ADDENDUM 2

DATE: February 22, 2017
PROJECT: JLL Roof Replacement and Waterproofing Project
RFP NO: 744-R1712
OWNER: The University of Texas Health Science Center at Houston
TO: Prospective Proposers

**UNIVERSITY OF TEXAS HEALTH SCIENCE CENTER
JESSE JONES LIBRARY
ROOF REPLACEMENT AND EXTEIOR WALL REPAIRS/RESTORATION
1133 JOHN FREEMAN BOULEVARD
HOUSTON, TEXAS**

**ADDENDUM NO. 1
FEBRUARY 17, 2017**

1 **ROOF TAPERED/SLOPE, WALK-PAD LAYOUT, LAY-DOWN AREAS, GUARD RAIL, PROPOSED GUARDRAIL AND ROOF ACCESS PLAN:**
 SCALE: 1"=20'-0"(11"x17"); 1"=10'-0"(22"x34")

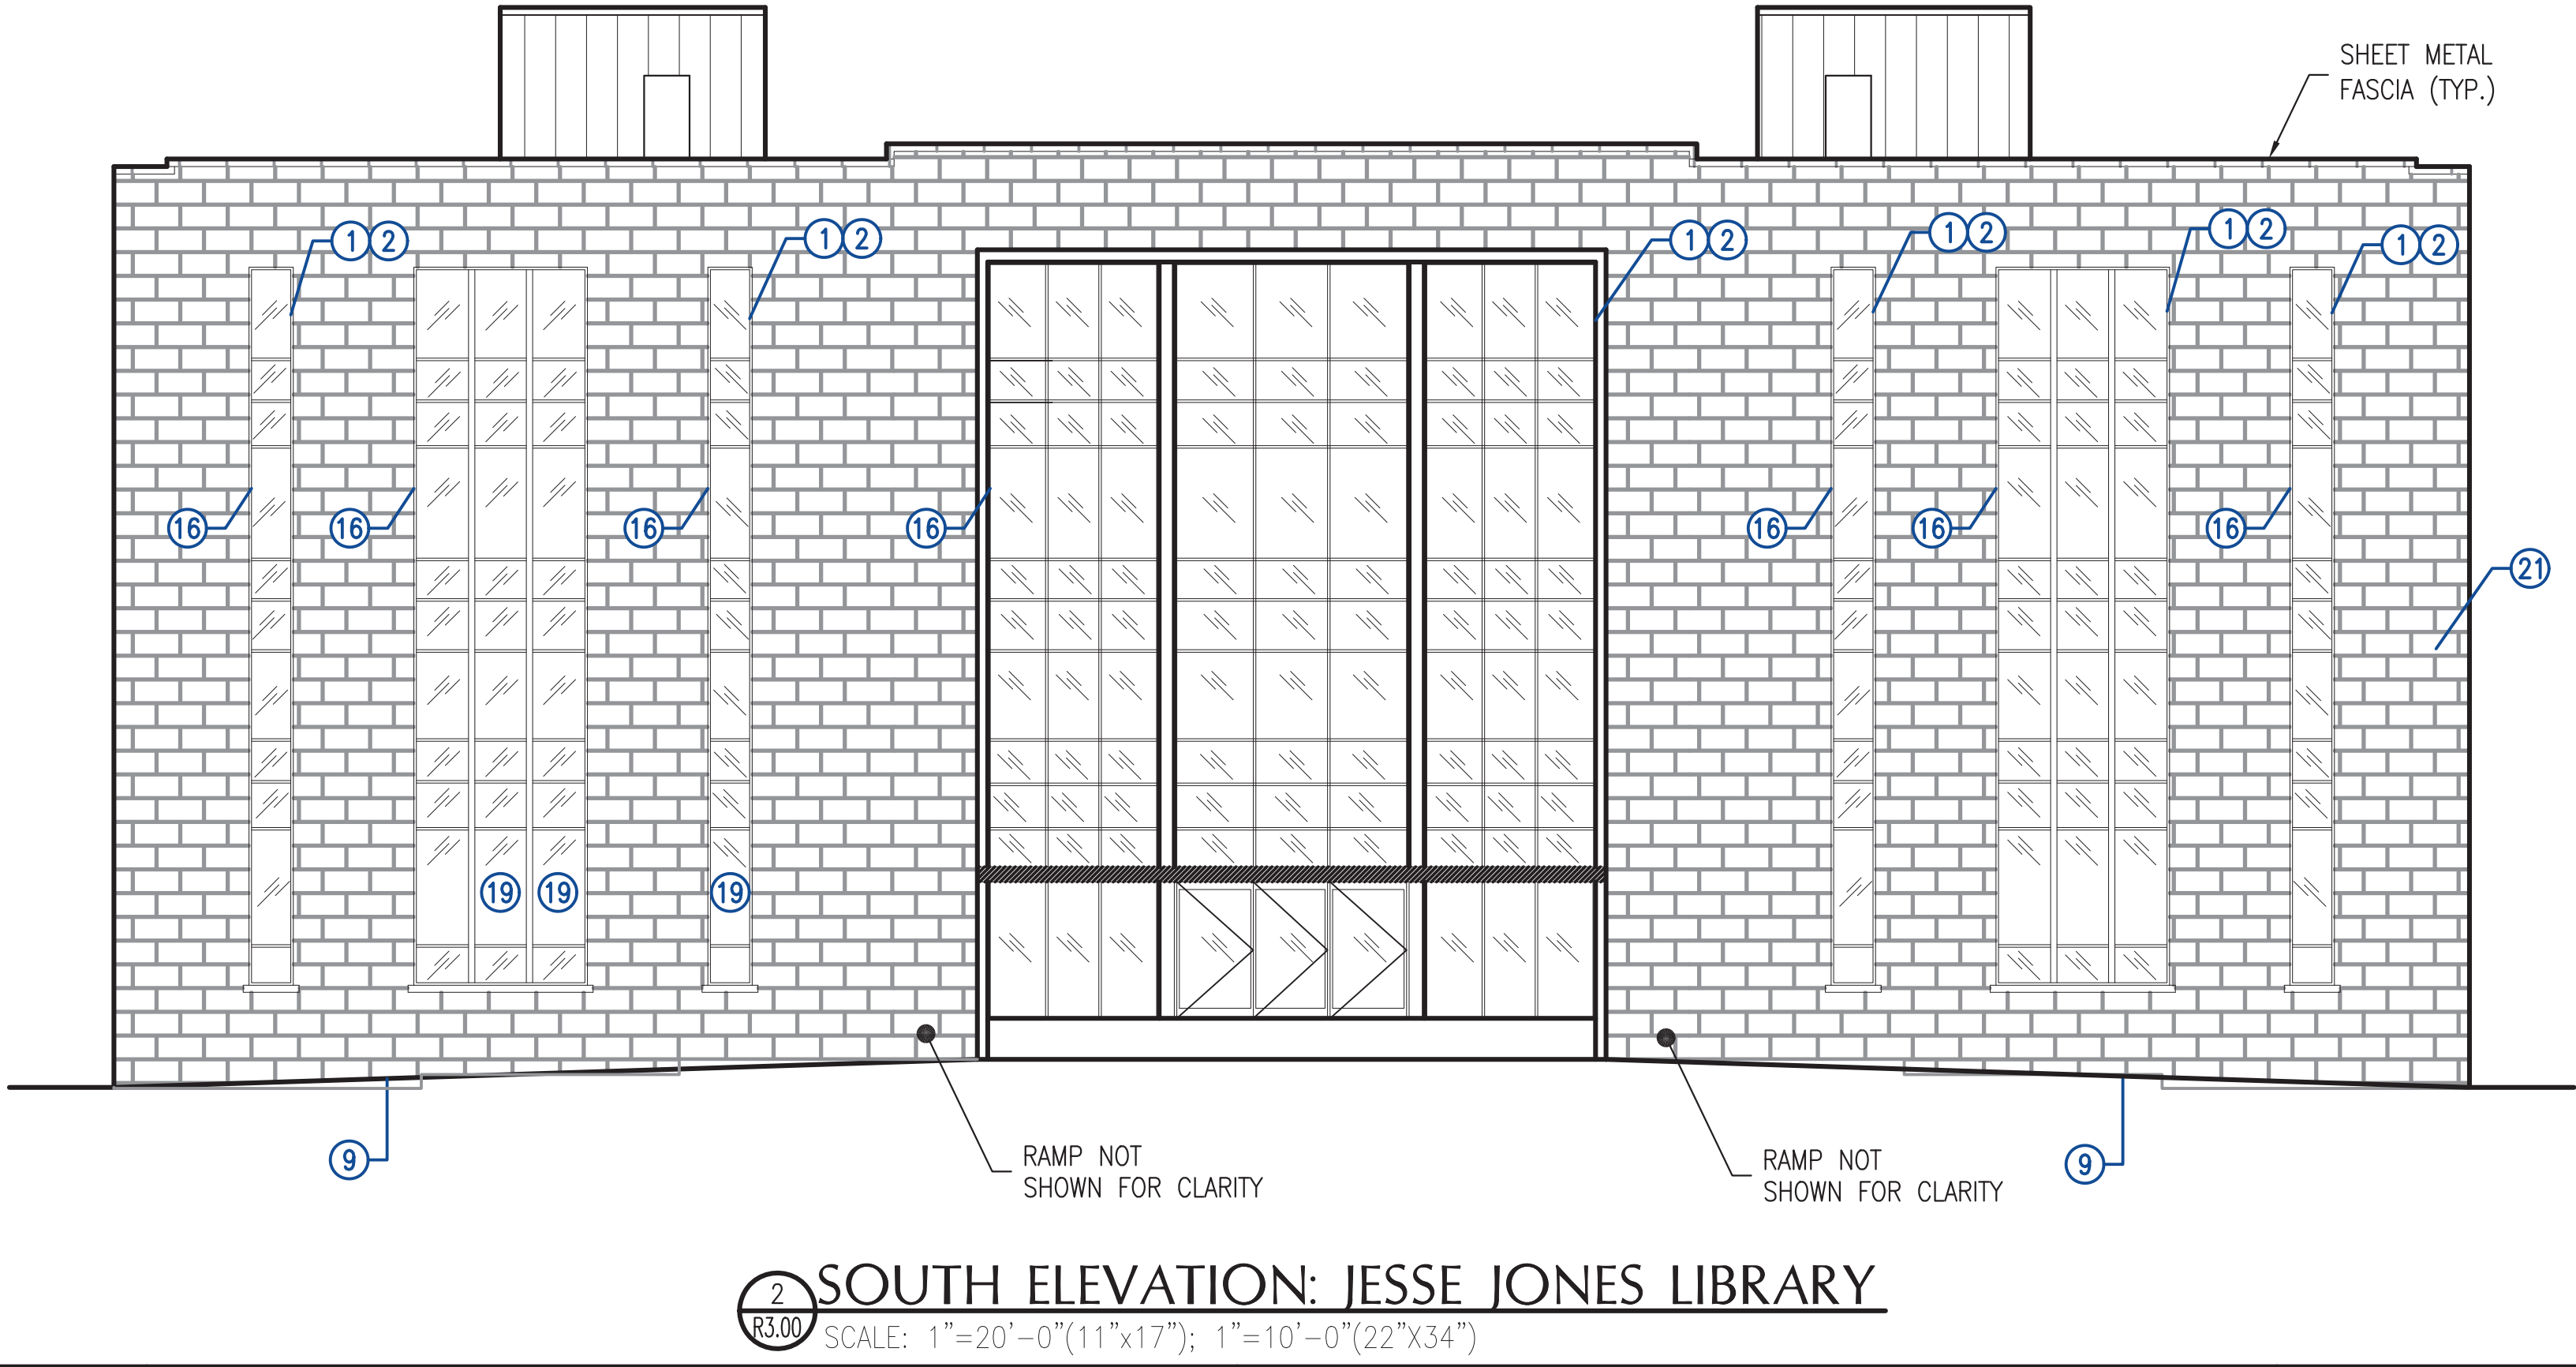
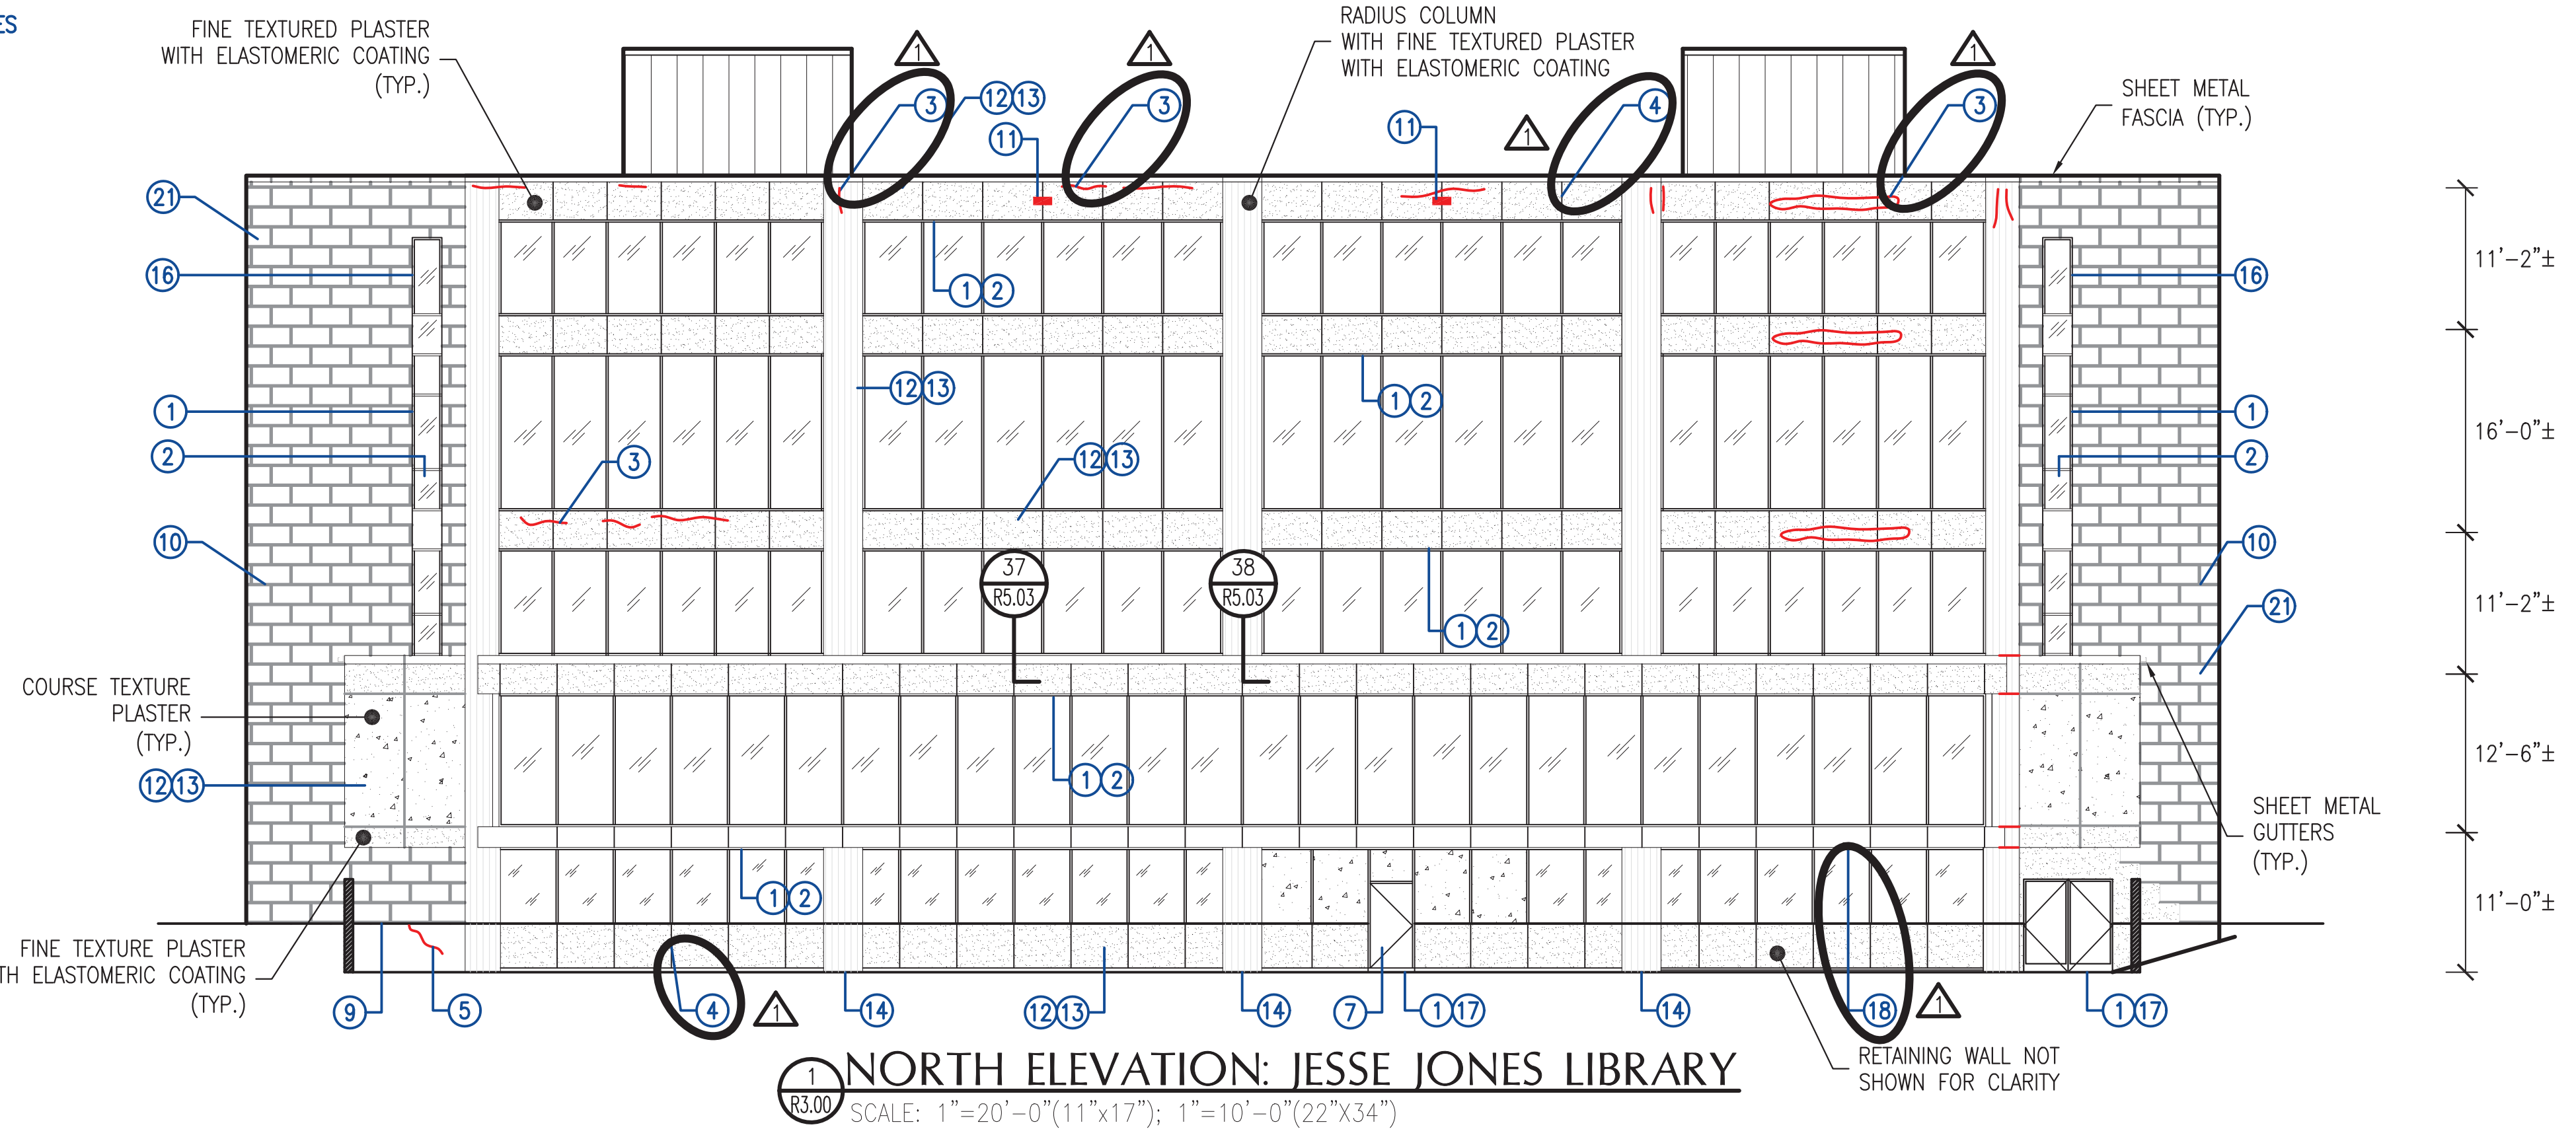
7. Sheet R2.02 – Roof Layout Plan: Add illustration of equipment curb and pipe box penetration on roof Area “H”. Reference attached revised Sheet R2.02.

DWN.BY: ESG
DATE: 01/20/17
SHEET: R3.00

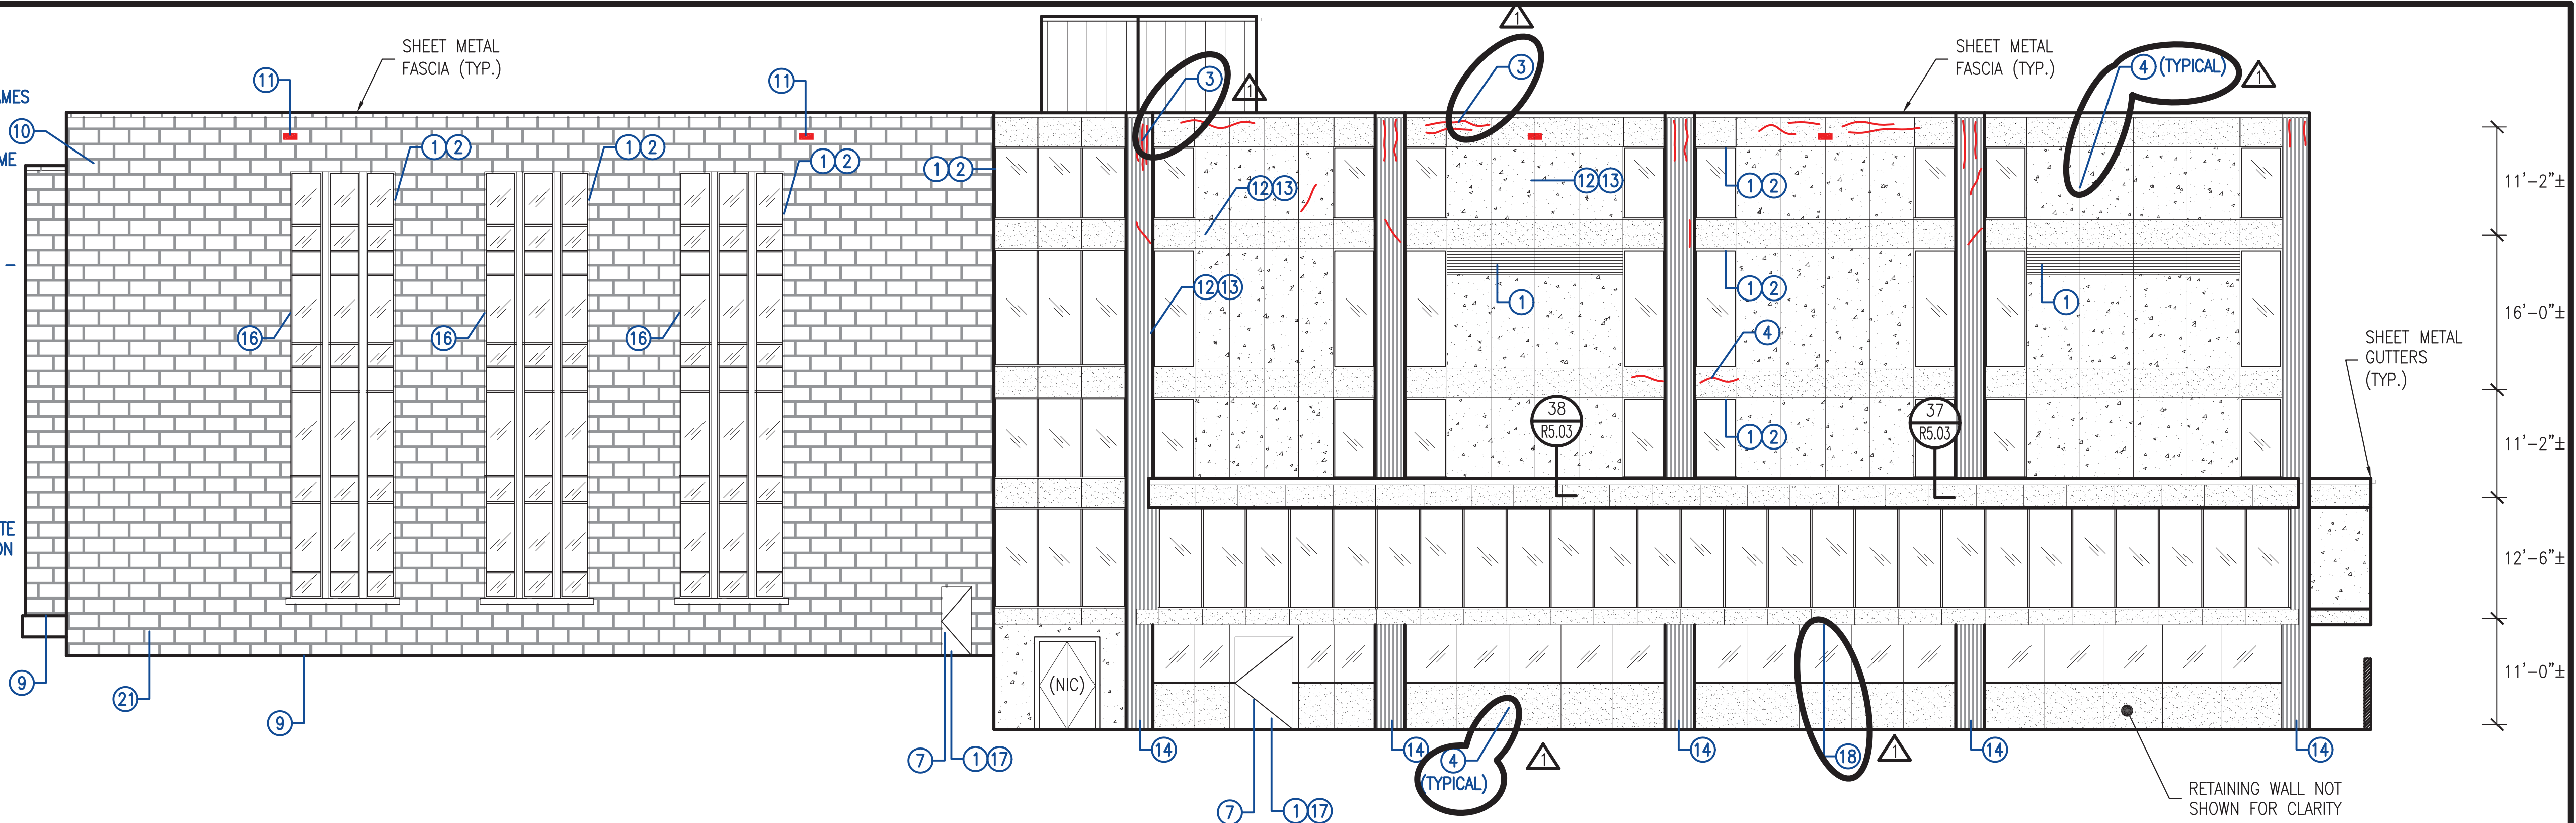
8. Sheet R3.00 – Elevations: Elevation 1/R3.00: Change Repair Note designation “4” to “3” on elevation; Add Repair Note “4” designation at respective locations on elevation; Add Repair Note “18” to underside of floor slab at lower level walkway at respective locations on elevation. Reference attached revised Sheet R3.00.

1 EAST ELEVATION: JESSE JONES LIBRARY

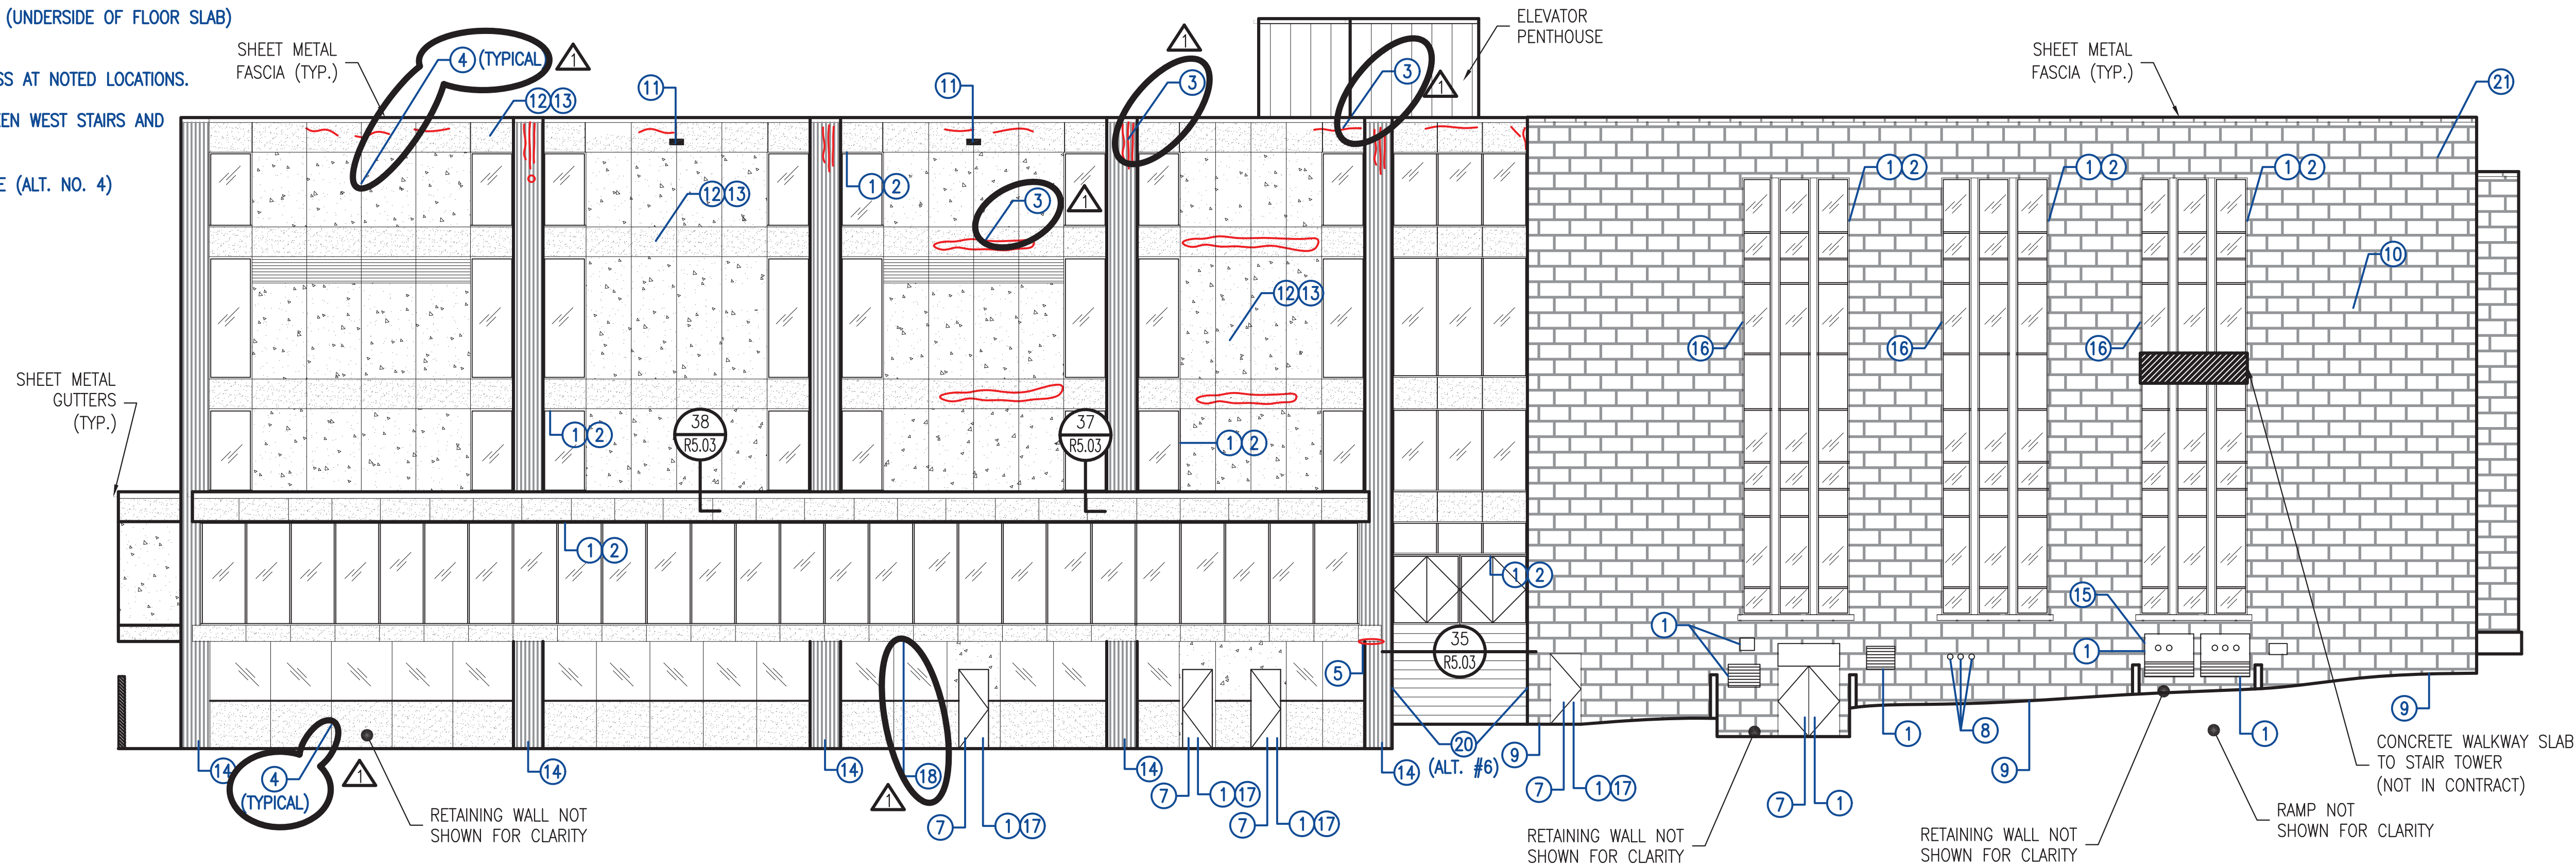
9. Sheet R3.01 – Elevations: Elevations 1/R3.01 and 2/R3.01: Change Repair Note designations “4” to “3 on elevations; Add Repair Note “4” designation at respective locations; Add Repair Note “18” to underside of floor slab at lower level walkway at respective locations on elevations. Reference attached revised Sheet R3.01.
